May 4, 2018
(Revised May 7, 2018)

Subject: Engineering Consultation
Golden Peak Improvements Project
Vail Ski Area
Vail, Colorado
Project No. GS06142.000-145

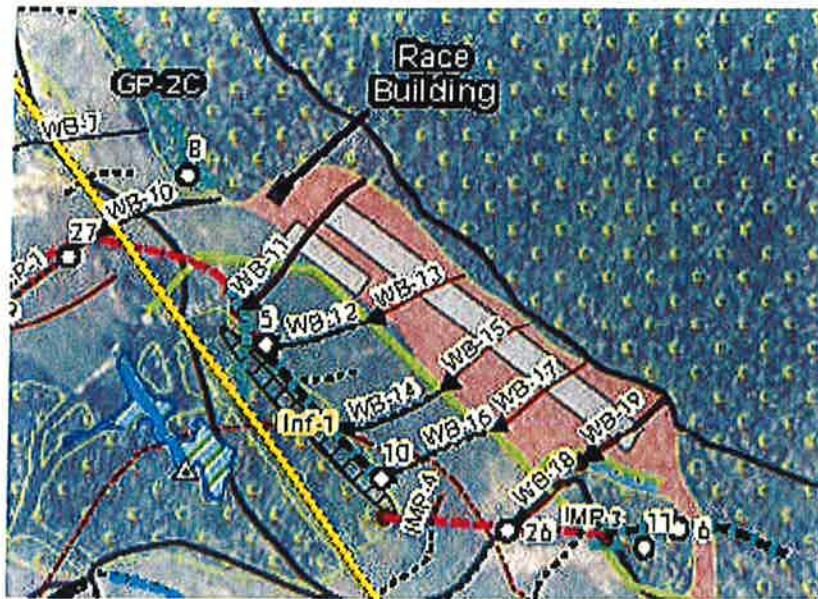
Our document review indicates that the potential volume and flow rate of water directed toward the slopes above Northwoods has not been analyzed. The amount of water and sediment loads may be significant, especially if the Golden Peak features are constructed as proposed. A profile of the slope from the bottom of the mogul course to the ridge top above Northwoods is shown below.

This slope profile, generated with Google Earth, indicates that surface and subsurface water at the base of the mogul course is likely to travel to the slopes directly above the Northwoods property. Tree clearing, reshaped surface grades, and additional manmade snow required for the course is likely to increase the amount of surface runoff and subsurface water to the slope directly above Northwoods. This could increase driving forces for slope failures and sediment loads resulting in mudfloods and mudflows.

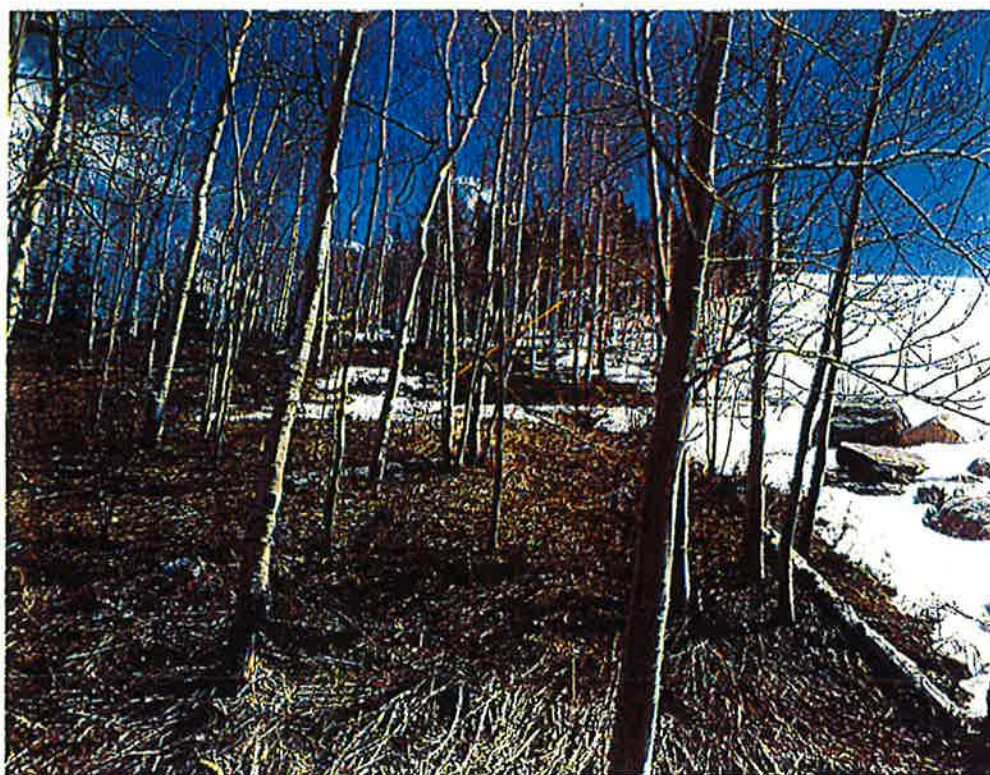
Drainage improvements related to basin GP-2G and the mogul course are indicated on the photograph below. New water bars (i.e., ditches) WB-11, WB-13, WB-15, WB-17 and WB-19 are proposed to be built. Existing water bars WB-7, WB-10, WB-12, WB-14 and WB-16 would be improved and enlarged. The existing drainage channel IMP-3 would be enlarged with enhanced erosion control.

The planned drainage improvements are positive, but not designed with the intent of mitigating risk of landslides, mudfloods, and mudflows that could affect Northwoods. Considering that a substantial degree of risk from flooding and mudflow currently exists and mogul course construction could increase the risk, we recommend this risk be evaluated. We can provide evaluation of the potential flood, mudflow and slope stability risks for the Northwoods HOA if desired. Potential mitigation may range from not constructing the mogul course, moving of the planned mogul course, or construction of berms, lined detention ponds and subsurface drains.
